ADDENDUM NO. 2

STADIUM LIGHTING

LITTLE JOB #612-12353-02

Hueneme High School

PROJECT NO. 6121235302
 ISSUE DATE 09/04/2020
 REFERENCE ED-200
 DRAWING # AD2-E1

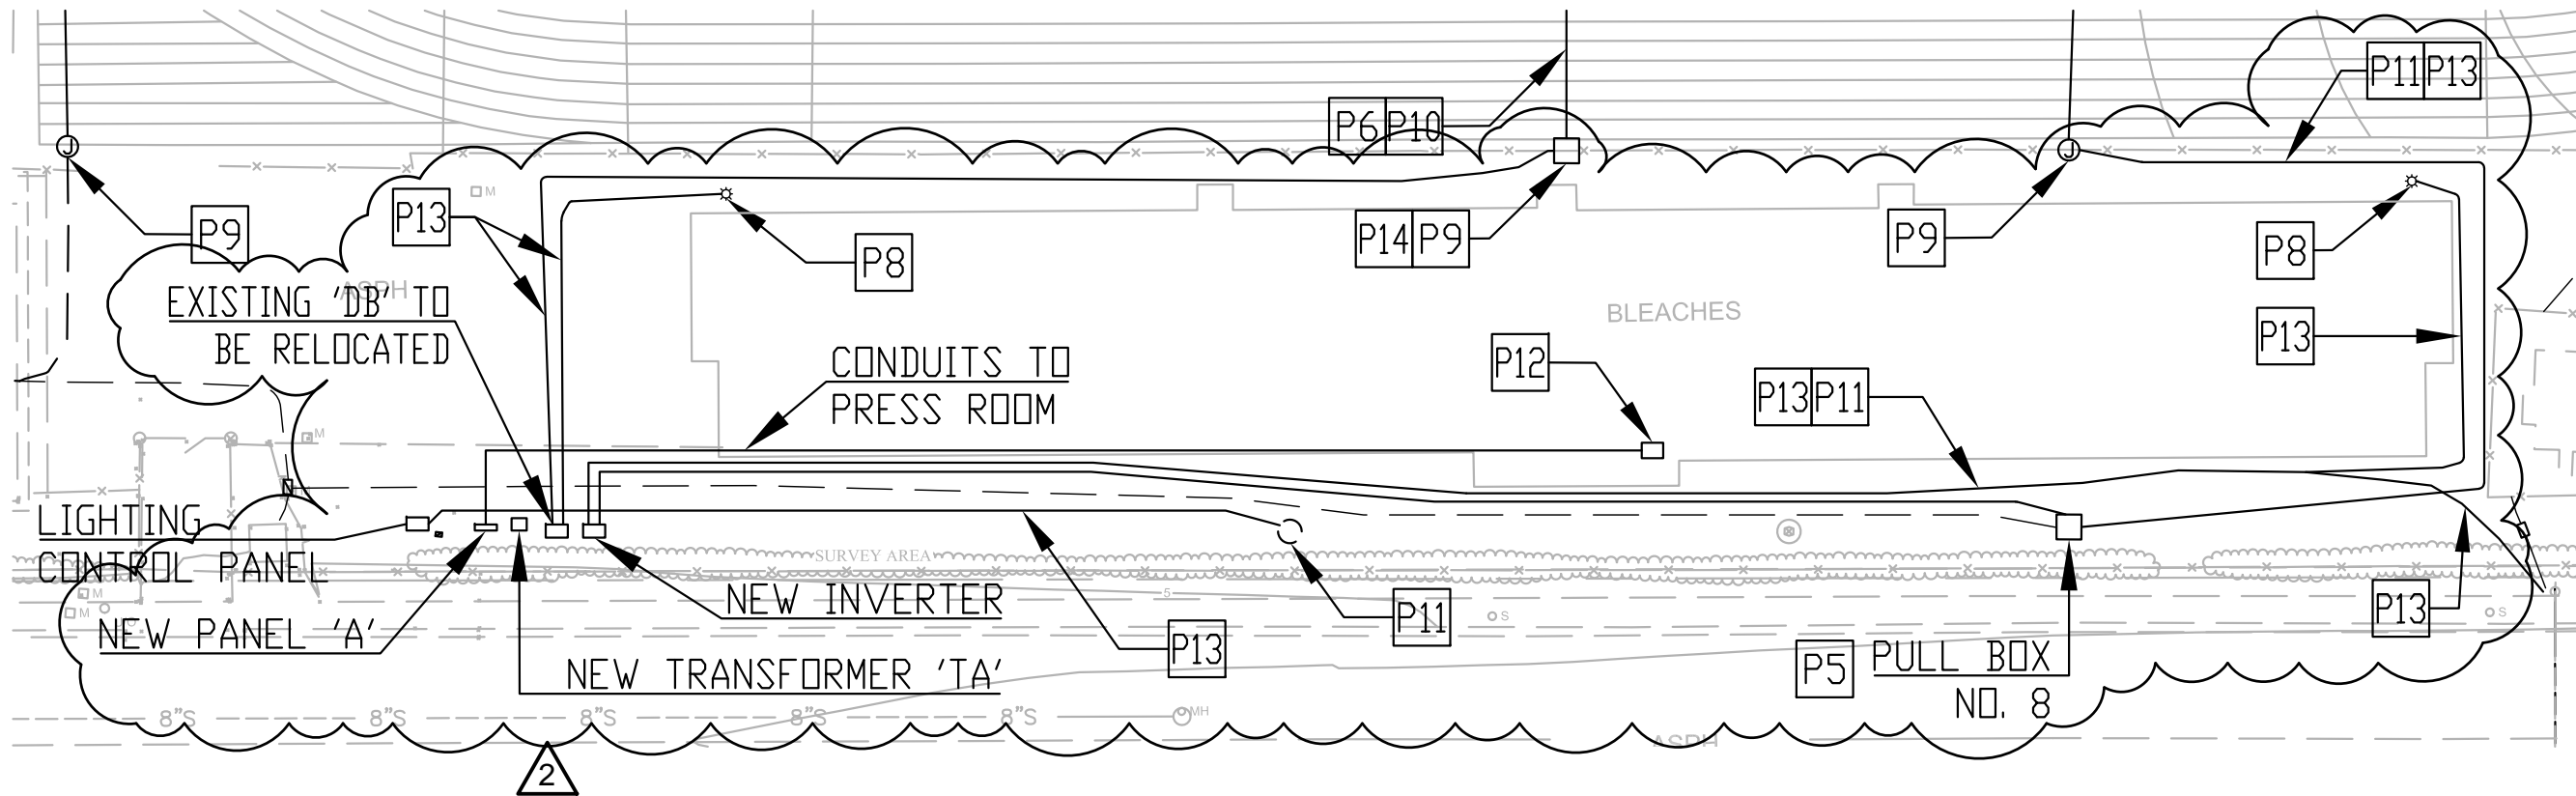
3.1.1.1. Drawing ED-200: Revise currently issued Drawing per AD2-E1.

- D1 ELECTRICAL CONTRACTOR SHALL VERIFY LOCATION AND SIZING OF EXISTING JUNCTION BOXES, CONDUITS, AND CONDUCTORS, PRIOR REMOVING AND DEMOLISHING FROM EXISTING AREA.
- D2 EXISTING LIGHT POLE TO BE RETROFITTED WITH LED. EXISTING STADIUM LIGHT FIXTURE AND SPEAKERS TO BE REMOVED, CAP ALL THE EXISTING WIRES AND CONNECTIONS FOR THE NEW RETROFITTED FIXTURES AND SPEAKERS. CONTRACTOR SHALL DELIVER REMOVE ITEMS TO DISTRICT.
- D3 EXISTING LIGHT POLE TO BE REMOVED FROM EXISTING LOCATION AND CONDUITS/CONDUCTORS TO BE STUBBED OUT FOR NEW WORK.
- D4 EXISTING PULL BOXES #7 & #8 TO BE REMOVED.
- D5 DEMOLISH EXISTING CONDUIT AND CONDUCTOR AND STUB OUT FOR NEW WORK.
- 2 D6 EXISTING CONDUITS AND CONDUCTORS TO BE REROUTED AND EXTENDED AS NEEDED PER NEW ROUTE.
